Nucor Steel West Virginia LLC
West Virginia Steel Mill
Permit Application: R14-0039
Plant ID No.: 053-00085

RE: **Response to Comments**
Nucor Steel West Virginia LLC
West Virginia Steel Mill
Permit No. R14-0039
Plant ID No. 053-00085

To: Joe Kessler
From: Jon McClung
CC: David Fewell, Bev McKeone, Ed Andrews, Steve Pursley, Rex Compston
Date: May 4, 2022
Re: Responses to EPA Region 3 Comments on Nucor's Air Quality Impact Analysis
Nucor Steel West Virginia LLC
West Virginia Steel Mill
PSD Permit Application: R14-0039
Plant ID: 053-00085

**West Virginia Department of Environmental Protection
Division of Air Quality
Response to comments on:**

Figure 1. AERSURFACE Sectors for Huntington Tri-State Airport

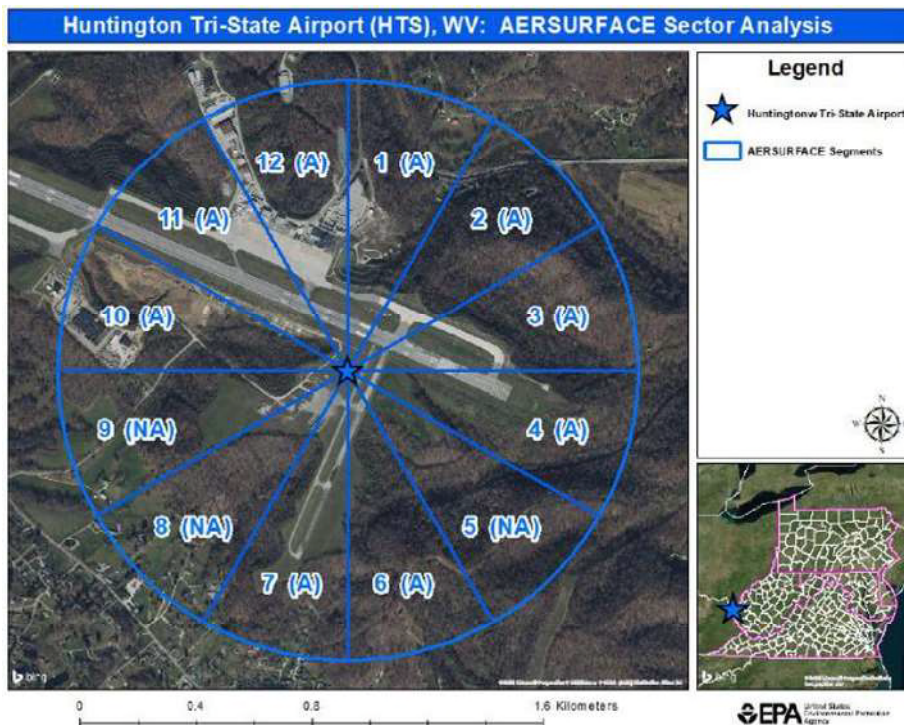
Comment 8: It appears that the final AERMET processed input files used average, no-snow conditions in AERSURFACE. Surface roughness values were determined for 12 equal 30-degree sectors out to 1-km. The AERSURFACE input file indicates Nucor defined 9 sectors as “Airport” and 3 sectors as “Non-Airport”. EPA Figure 1 shows the 12 sectors surrounding the HTS ASOS tower location, which was verified, and the AERSURFACE sector definitions (A = airport, NA = non-airport). Visually, most of the sector definitions appear to be assessed. Additional discussion on how to determine sector definitions (airport versus nonairport) can be found in EPA’s AERSURFACE users guide sections 2.3.2, 2.4.1.3 and 3.2.10.

WVDAQ Response: WVDAQ agrees that Nucor properly assessed the airport/non-airport designations in the AERSURFACE analysis. Nucor appropriately designated the project site as not having continuous snow cover (“no snow”) and used average precipitation conditions for 2016, 2017, and 2020 and used wet precipitations for 2018 and 2019.

Figure 2. Nucor 1-Hour SO₂ Modeling Analysis Overview

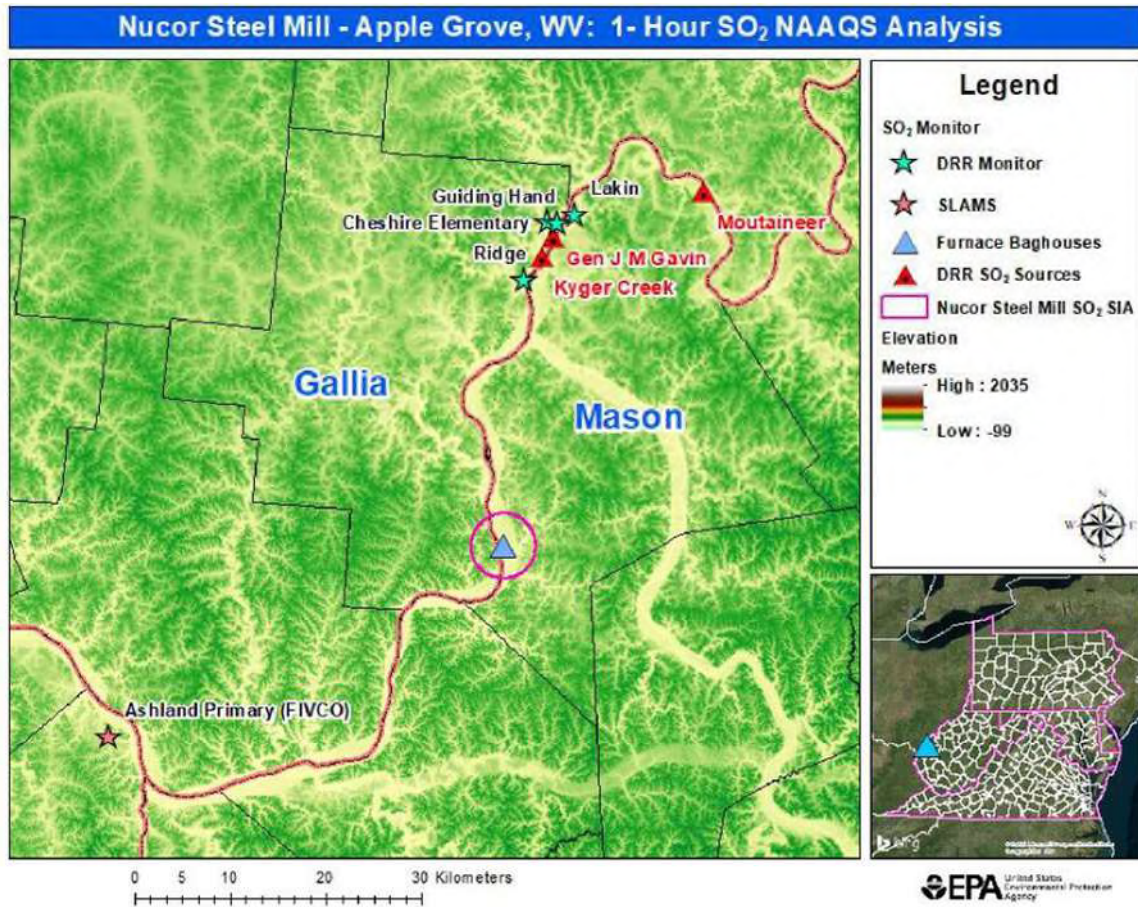
To gauge the impact of the large DRR sources north of the Nucor steel mill in Gallia and Mason counties, EPA reran Nucor’s 1-hr SO₂ NAAQS analysis using a 1-hr season by hour of day background concentration for the Lakin, WV (54-053-0001) DRR monitor. This monitor should provide a very conservative background concentration since it is located much closer to the Gavin and Kyger Creek DRR sources than the Nucor steel mill is. Table 1 shows the EPA constructed season by hour of day background SO₂ concentrations for the Lakin, WV monitor. Hour 1 values are probably missing due to that hour being used for daily calibration and maintenance activities. Modeled background concentrations for this hour were interpolated based on the hour 24 and hour 2 values.

Background concentrations are higher during the daytime hours and the spring, summer and fall seasons. Gavin and Kyger Creek’s primary stacks are very high, over 200 meters based on the model input files, so vertical mixing must take place to bring stack emissions to ground level where the monitor is located. This accounts for daytime and the seasonal trends in the background concentrations. Vertical mixing is generally greatest during the daytime hours and outside of the cooler winter months when morning inversions are stronger and can limit daytime mixing depths.

EPA used Nucor’s receptor grid, which is limited to portions of the plant’s SIA (where its emissions could exceed the 1-hr SO₂ significant impact levels) and extends roughly 3.4 km from the steel mill. Additionally, EPA reprocessed the AERMET input files to use the filled in Pittsburgh, PA upper air soundings as described in Comment 13. This reduced the number of “missing” hours summarized in the AERMOD output file from 919 hours to 766 hours.

Figure 1. AERSURFACE Sectors for Huntington Tri-State Airport

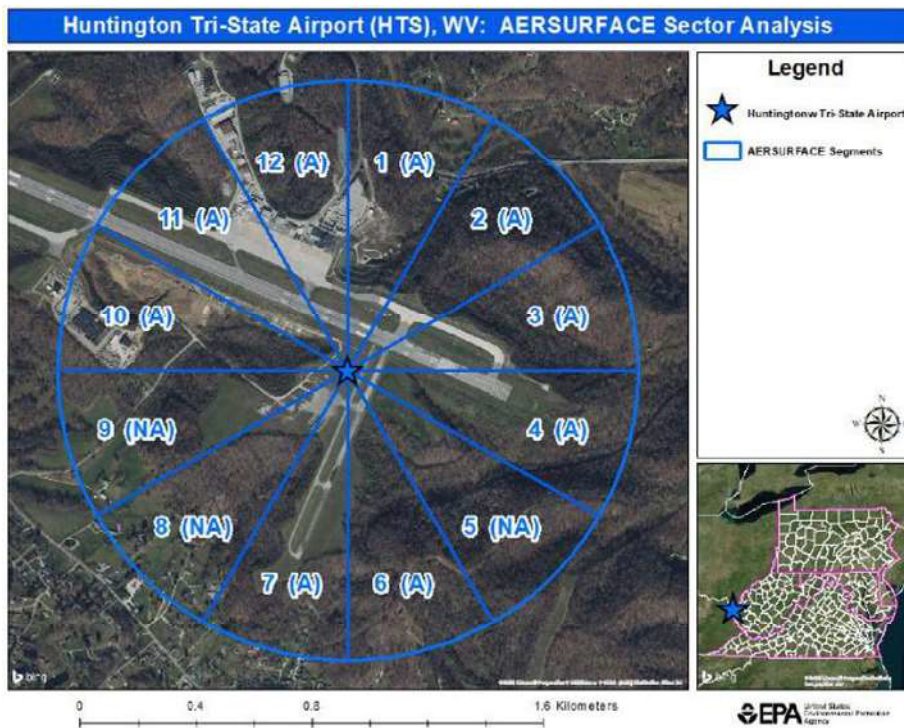
Comment 8: It appears that the final AERMET processed input files used average, no-snow conditions in AERSURFACE. Surface roughness values were determined for 12 equal 30-degree sectors out to 1-km. The AERSURFACE input file indicates Nucor defined 9 sectors as “Airport” and 3 sectors as “Non-Airport”. EPA Figure 1 shows the 12 sectors surrounding the HTS ASOS tower location, which was verified, and the AERSURFACE sector definitions (A = airport, NA = non-airport). Visually, most of the sector definitions appear to be assessed. Additional discussion on how to determine sector definitions (airport versus nonairport) can be found in EPA’s AERSURFACE users guide sections 2.3.2, 2.4.1.3 and 3.2.10.

WVDAQ Response: WVDAQ agrees that Nucor properly assessed the airport/non-airport designations in the AERSURFACE analysis. Nucor appropriately designated the project site as not having continuous snow cover (“no snow”) and used average precipitation conditions for 2016, 2017, and 2020 and used wet precipitations for 2018 and 2019.

Figure 2. Nucor 1-Hour SO₂ Modeling Analysis Overview

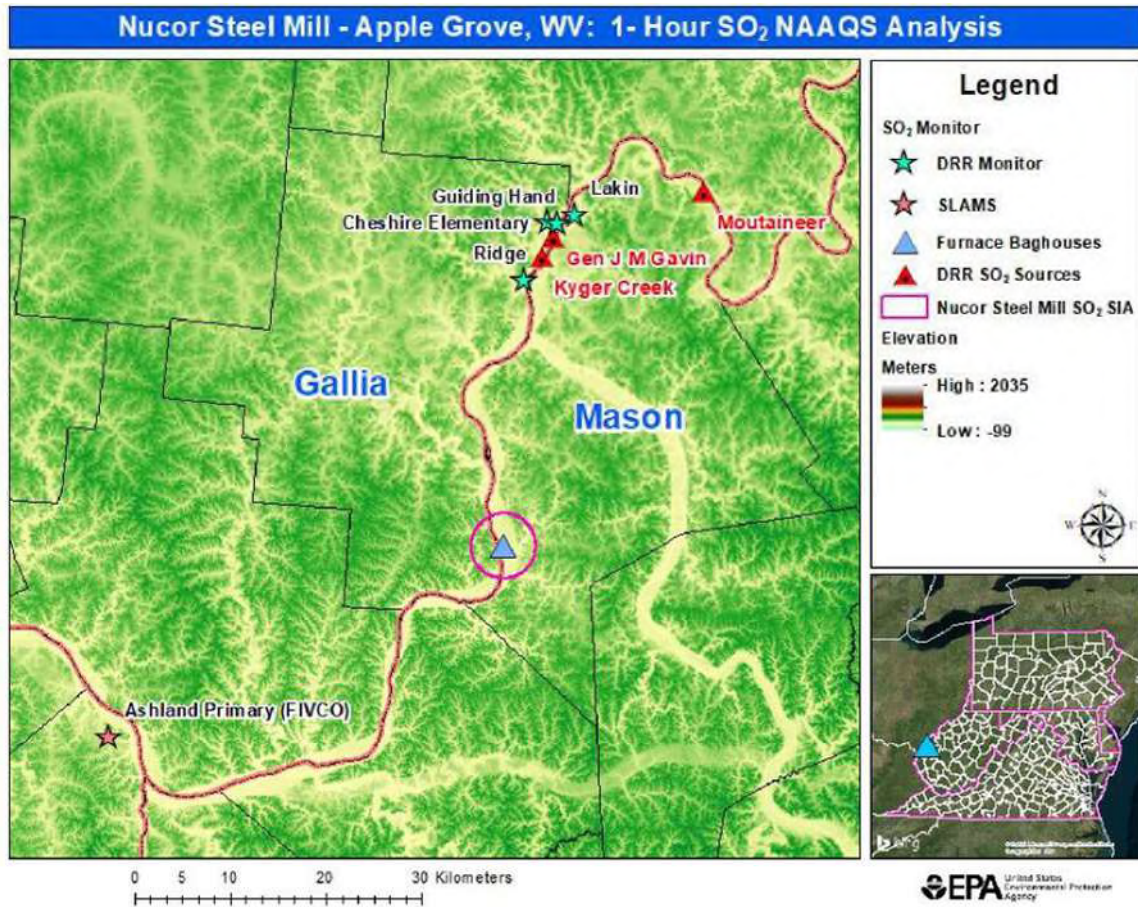
To gauge the impact of the large DRR sources north of the Nucor steel mill in Gallia and Mason counties, EPA reran Nucor’s 1-hr SO₂ NAAQS analysis using a 1-hr season by hour of day background concentration for the Lakin, WV (54-053-0001) DRR monitor. This monitor should provide a very conservative background concentration since it is located much closer to the Gavin and Kyger Creek DRR sources than the Nucor steel mill is. Table 1 shows the EPA constructed season by hour of day background SO₂ concentrations for the Lakin, WV monitor. Hour 1 values are probably missing due to that hour being used for daily calibration and maintenance activities. Modeled background concentrations for this hour were interpolated based on the hour 24 and hour 2 values.

Background concentrations are higher during the daytime hours and the spring, summer and fall seasons. Gavin and Kyger Creek’s primary stacks are very high, over 200 meters based on the model input files, so vertical mixing must take place to bring stack emissions to ground level where the monitor is located. This accounts for daytime and the seasonal trends in the background concentrations. Vertical mixing is generally greatest during the daytime hours and outside of the cooler winter months when morning inversions are stronger and can limit daytime mixing depths.

EPA used Nucor’s receptor grid, which is limited to portions of the plant’s SIA (where its emissions could exceed the 1-hr SO₂ significant impact levels) and extends roughly 3.4 km from the steel mill. Additionally, EPA reprocessed the AERMET input files to use the filled in Pittsburgh, PA upper air soundings as described in Comment 13. This reduced the number of “missing” hours summarized in the AERMOD output file from 919 hours to 766 hours.

Figure 1. AERSURFACE Sectors for Huntington Tri-State Airport

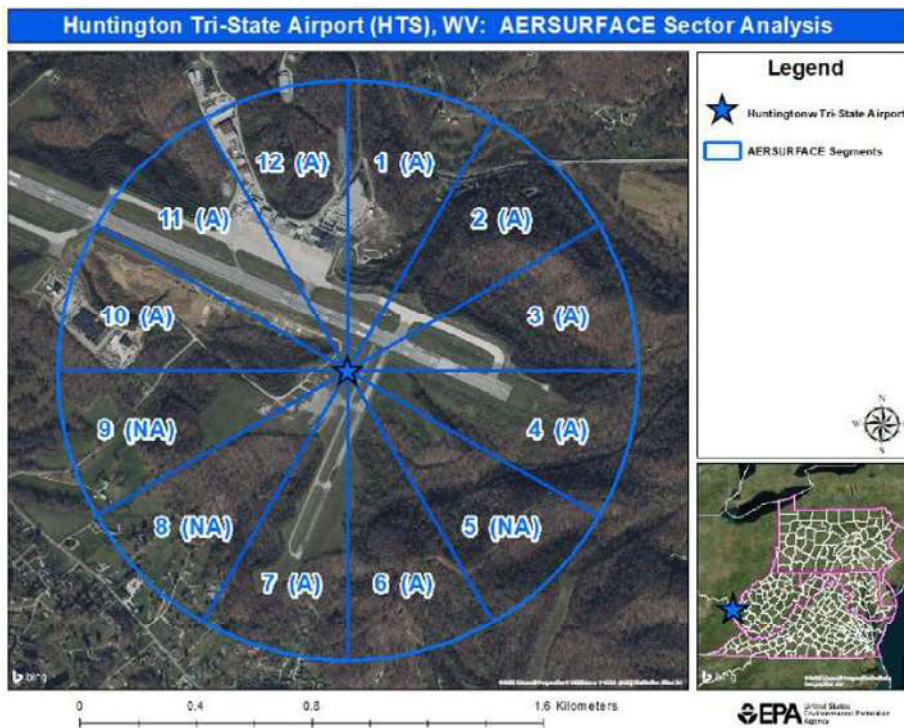
Comment 8: It appears that the final AERMET processed input files used average, no-snow conditions in AERSURFACE. Surface roughness values were determined for 12 equal 30-degree sectors out to 1-km. The AERSURFACE input file indicates Nucor defined 9 sectors as “Airport” and 3 sectors as “Non-Airport”. EPA Figure 1 shows the 12 sectors surrounding the HTS ASOS tower location, which was verified, and the AERSURFACE sector definitions (A = airport, NA = non-airport). Visually, most of the sector definitions appear to be assessed. Additional discussion on how to determine sector definitions (airport versus nonairport) can be found in EPA’s AERSURFACE users guide sections 2.3.2, 2.4.1.3 and 3.2.10.

WVDAQ Response: WVDAQ agrees that Nucor properly assessed the airport/non-airport designations in the AERSURFACE analysis. Nucor appropriately designated the project site as not having continuous snow cover (“no snow”) and used average precipitation conditions for 2016, 2017, and 2020 and used wet precipitations for 2018 and 2019.

Figure 2. Nucor 1-Hour SO₂ Modeling Analysis Overview

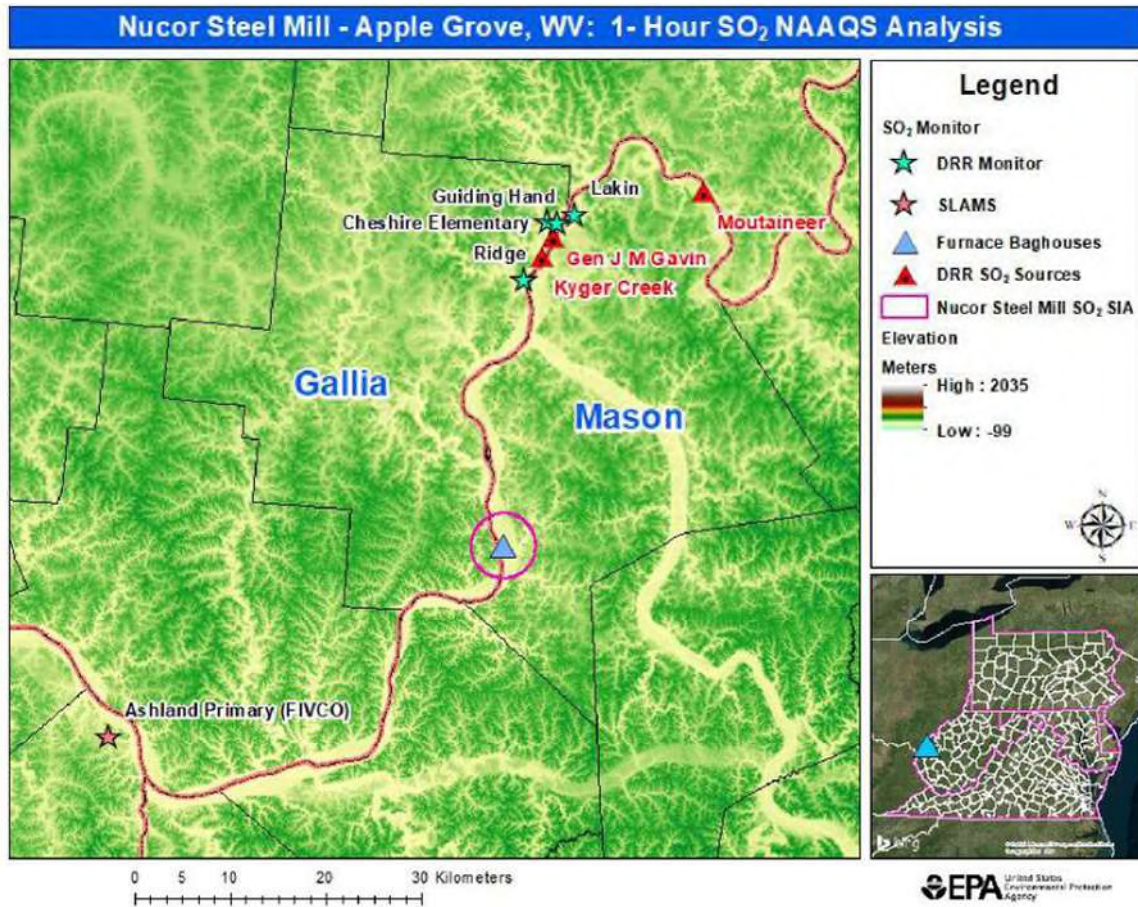
To gauge the impact of the large DRR sources north of the Nucor steel mill in Gallia and Mason counties, EPA reran Nucor’s 1-hr SO₂ NAAQS analysis using a 1-hr season by hour of day background concentration for the Lakin, WV (54-053-0001) DRR monitor. This monitor should provide a very conservative background concentration since it is located much closer to the Gavin and Kyger Creek DRR sources than the Nucor steel mill is. Table 1 shows the EPA constructed season by hour of day background SO₂ concentrations for the Lakin, WV monitor. Hour 1 values are probably missing due to that hour being used for daily calibration and maintenance activities. Modeled background concentrations for this hour were interpolated based on the hour 24 and hour 2 values.

Background concentrations are higher during the daytime hours and the spring, summer and fall seasons. Gavin and Kyger Creek’s primary stacks are very high, over 200 meters based on the model input files, so vertical mixing must take place to bring stack emissions to ground level where the monitor is located. This accounts for daytime and the seasonal trends in the background concentrations. Vertical mixing is generally greatest during the daytime hours and outside of the cooler winter months when morning inversions are stronger and can limit daytime mixing depths.

EPA used Nucor’s receptor grid, which is limited to portions of the plant’s SIA (where its emissions could exceed the 1-hr SO₂ significant impact levels) and extends roughly 3.4 km from the steel mill. Additionally, EPA reprocessed the AERMET input files to use the filled in Pittsburgh, PA upper air soundings as described in Comment 13. This reduced the number of “missing” hours summarized in the AERMOD output file from 919 hours to 766 hours.

Figure 1. AERSURFACE Sectors for Huntington Tri-State Airport

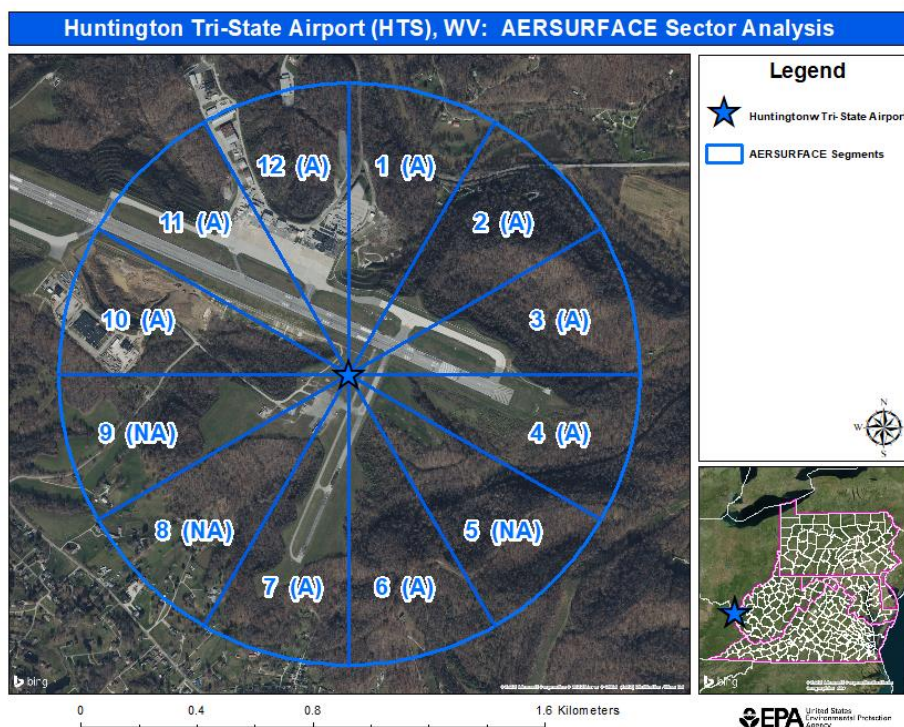
Comment 8: It appears that the final AERMET processed input files used average, no-snow conditions in AERSURFACE. Surface roughness values were determined for 12 equal 30-degree sectors out to 1-km. The AERSURFACE input file indicates Nucor defined 9 sectors as “Airport” and 3 sectors as “Non-Airport”. EPA Figure 1 shows the 12 sectors surrounding the HTS ASOS tower location, which was verified, and the AERSURFACE sector definitions (A = airport, NA = non-airport). Visually, most of the sector definitions appear to be correctly

assessed. Additional discussion on how to determine sector definitions (airport versus nonairport) can be found in EPA's AERSURFACE users guide sections 2.3.2, 2.4.1.3 and 3.2.10.

Figure 2. Nucor 1-Hour SO₂ Modeling Analysis Overview

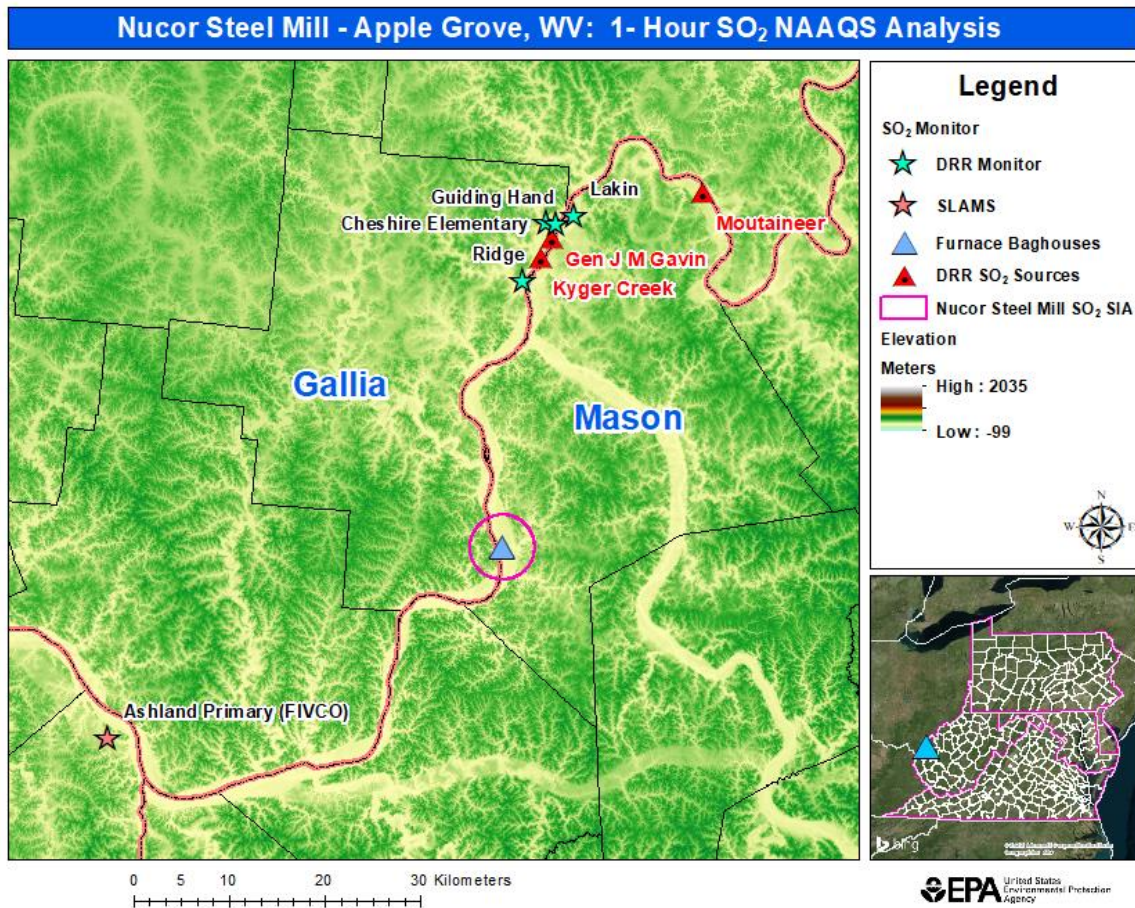
Background concentrations are higher during the daytime hours and the spring, summer and fall seasons. Gavin and Kyger Creek’s primary stacks are very high, over 200 meters based on the model input files, so vertical mixing must take place to bring stack emissions to ground level where the monitor is located. This accounts for daytime and the seasonal trends in the background concentrations. Vertical mixing is generally greatest during the daytime hours and outside of the cooler winter months when morning inversions are stronger and can limit daytime mixing depths.

EPA used Nucor’s receptor grid, which is limited to portions of the plant’s SIA (where its emissions could exceed the 1-hr SO₂ significant impact levels) and extends roughly 3.4 km from the steel mill. Additionally, EPA reprocessed the AERMET input files to use the filled in Pittsburgh, PA upper air soundings as described in Comment 13. This reduced the number of “missing” hours summarized in the AERMOD output file from 919 hours to 766 hours.
